How to update T32MZ

T32MZ SOFTWARE UPDATE CHANGES**(Editor Version: 3.7 Encoder version: 1.3)**

◆ Basic Menu screen

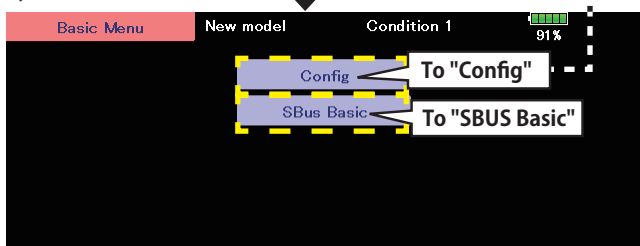
1. CH3 (THR) can be output to the RUD2 / S.BUS2 port.
2. The Holding Power rate of the aircraft in AVCS mode has been expanded to 5 types from C1 to C5, and each rate can be set by switching the display.
3. Added the setting of switching CH of Holding Power rate C1 to C5 to S.BUS basic menu.

◆ Config screen

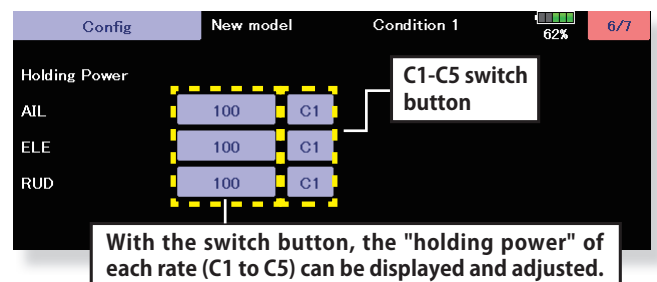
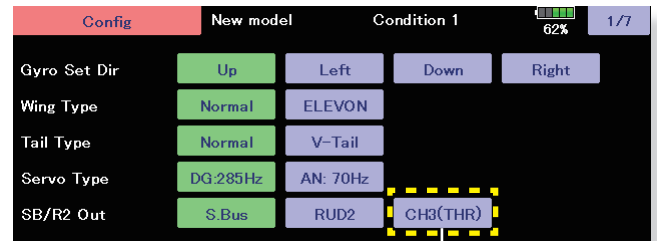
There are 7 pages in total, and the additional functions are 1 page and 6 pages.

◆ S.BUS Basic screen

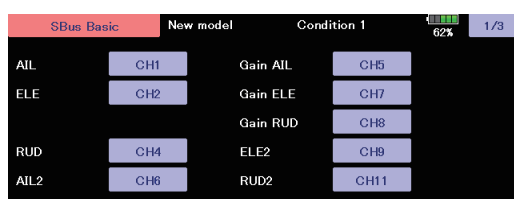
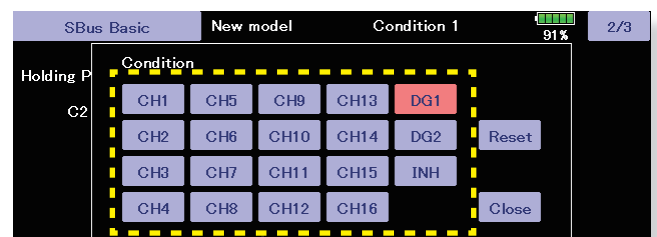
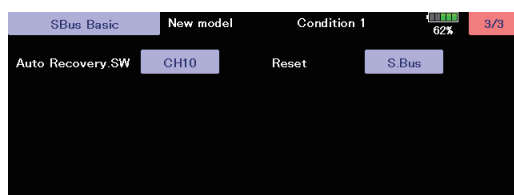
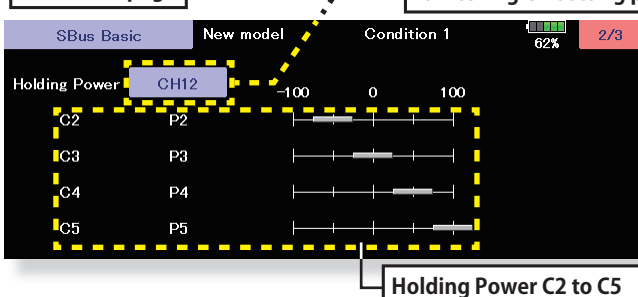
Added the setting of switching CH of holding power rate C1 to C5 to S.BUS basic menu.

The second page has been added, and the total number of pages has changed from 2 to 3.

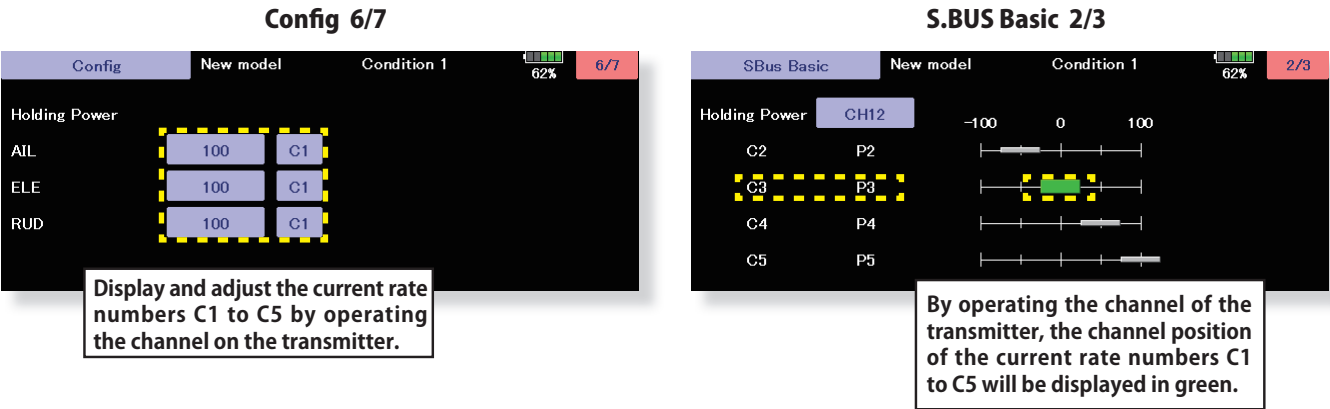
The current rate numbers C1 to C5 are displayed by operating the channel of the transmitter.

When set to SW of DG1 or DG2

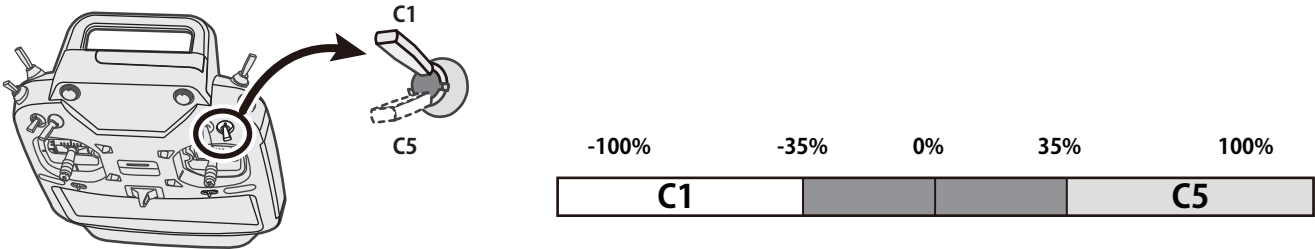
Like the flight condition function of the transmitter, you can set up to 5 different data for the attitude holding force rate of the aircraft in AVCS mode by operating the switch from the transmitter, and switch between them. You can set the holding power rate selector switch to the channel with the AFR function of the transmitter, and set the point for each rate on the AFR point curve to switch. It is also possible to use the flight condition function to work with the flight condition switch.

◆ Register the ESC with the transmitter.

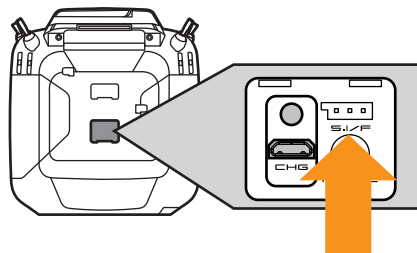
1. Select **[Sensor]** on the second page of the linkage menu.
2. Open the second page of the sensor screen and tap the **Slot 24** button.
3. A list of sensors will be displayed, so select **Futaba ESC**.

◆ MC-9130H/A telemetry connection example

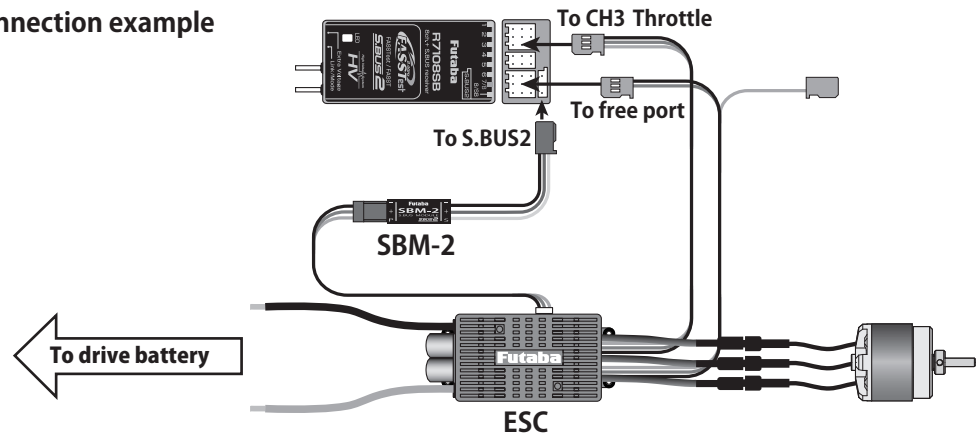
1. Futaba ESC, Hobbywing ESC telemetry compatible

Supports the telemetry function of the Futaba sensor "Futaba ESC" and the Hobbywing sensor "Hobbywing ESC".

2. Add R.P.M. display : Gov Basic

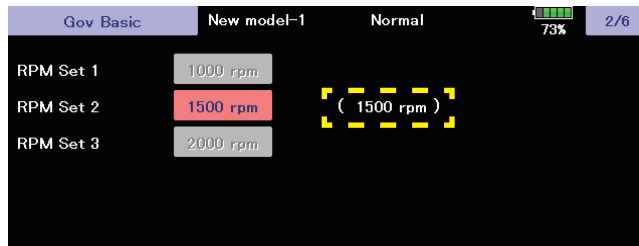
The number of revolutions of the governor setting is displayed on the governor basic screen of the gyro setting.

3. GYA553 Addition of setting parameters

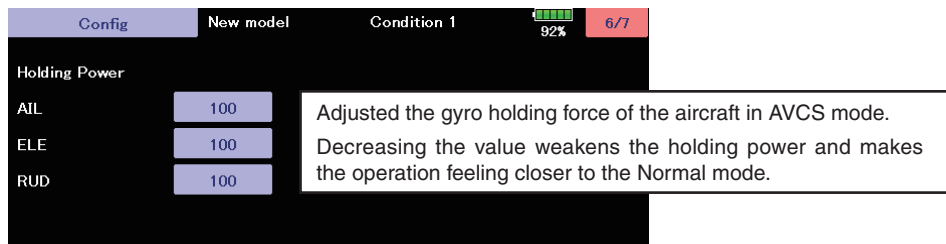
AIL / ELE / RUD holding power setting has been added to the setting parameters of GYA553.

4. Expansion of governor R.P.M. range

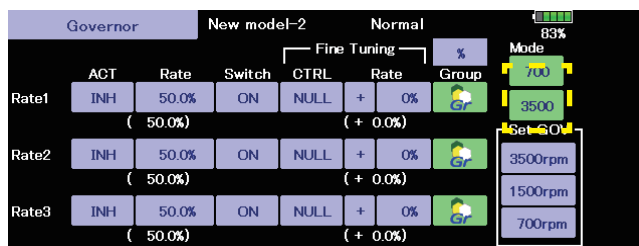
With the governor function of the model menu, the R.P.M. range has been expanded to 700 to 3500 rpm.

1. Add Screen off function [Quick start]

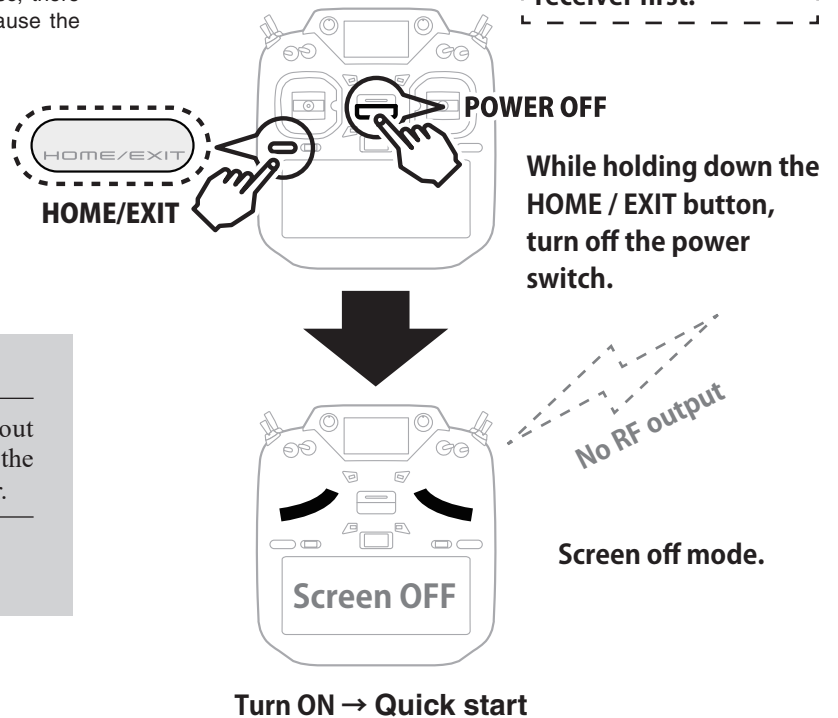
This "screen off" can quick start next startup. This is convenient when turning on and off frequently. No RF output at "screen off". Also, there is no screen display. However, the battery is consumed because the internal circuit is activated.
